Post-Concrete Pour Slab Report

Inspection Date: 9 Jul 2021

Property Address: Niddrie area

Non Compliant 2.04

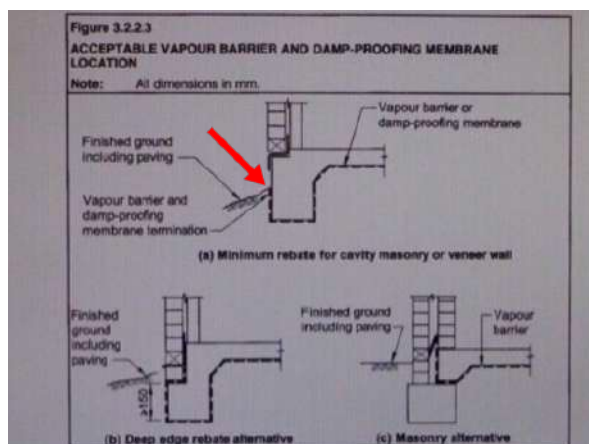
Finding: Polyethylene vapour barrier not installed as per BCA - Part 3.2.2.6

The vapour barrier system has NOT been completed and installed in accordance with AS2870 and BCA Part 3.2.2.6. ALL areas of non compliance are required to be repaired.

It is obvious that the concrete contractors have added additional plastic on the day of the concrete pour, however this added plastic is just sitting there.

The photos are very clear examples of the plastic doing nothing or minimal as the plastic MUST BE TAPED AT ALL PLASTIC JOINS at a minimum of 200mm overlap and taped with an appropriate tape and it clearly isn't the case on this job.

To entirely dig the external perimeter of the building at least 300mm below the vapour barrier system (black plastic) damaged areas, which will vary in areas and then overlap the existing plastic with the new plastic by a minimum of 200mm and taped.

The plastic must be hard against the concrete with no soil, rocks and/or builders debris in between the slab and the plastic.

Any over pour of concrete must be cut flush and include engineers report for alteration works and if steel is visually seen must now also be notified to the structural engineer to determine the remedial works.

Substandard Workmanship 3.01

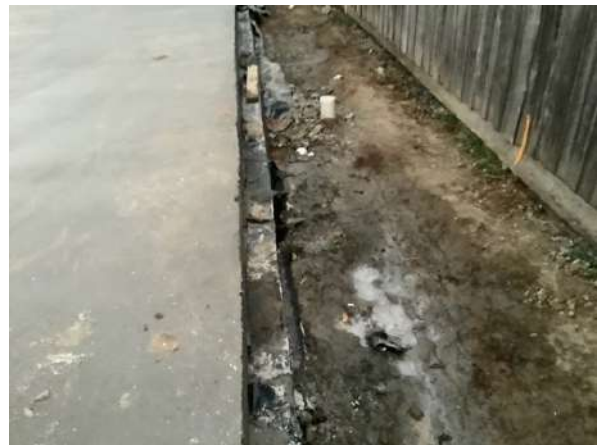
Location: All Areas
Finding: Builder Concrete Waste - Remaining

It was noted that there is excessive amount of concrete (builder waste) on the site in various areas. All builders waste must be removed as per the contract.

The builder must use all endeavours to ensure that the site is safe and left clean whilst in construction and a clean, builders waste free site prior to final handover as per the building act and contractual agreements.

For Your Information 5.03

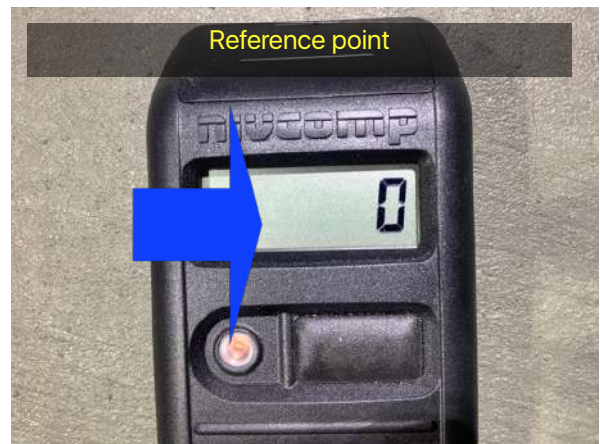
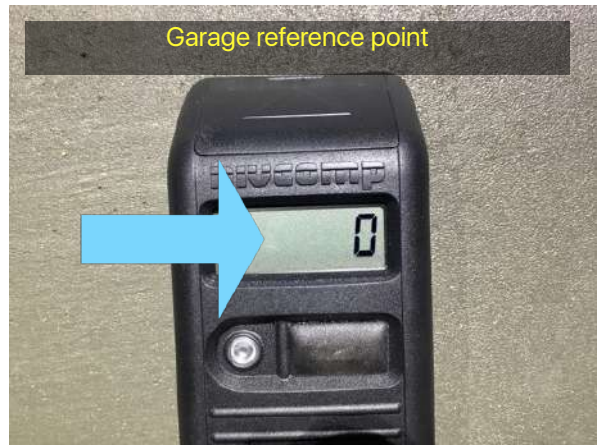
Location: All Areas
 Finding: Finished Concrete Floor Levels - Acceptable
 DIGITAL ELECTRONIC FLOOR LEVELLING

NOTE :
 THE PHOTOS WITH THE BLUE ARROWS INDICATE THE REFERENCE POINTS, WHICH DETERMINES IN MILLIMETRES IF THE OTHER LOCATIONS ARE HIGHER OR LOWER THEN THE REFERANCE POINTS WITH THE BLUE ARROWS.
 THIS PROPERTY INDICATES THAT THE FLOORING IS WITHIN TOLERANCES & IS WITHIN THE ACCEPTABLE AUSTRALIAN STANDARDS .

Whilst the concrete levels are within tolerance, it is important to note that there are levels that are out of level and/or close to out of tolerance.
 The concrete slab does appear to have a dish surface affect and I do recommend the builder take this into consideration when continuing the build process

I request that the builder take this into consideration and consider levelling the concrete prior to frame installation .
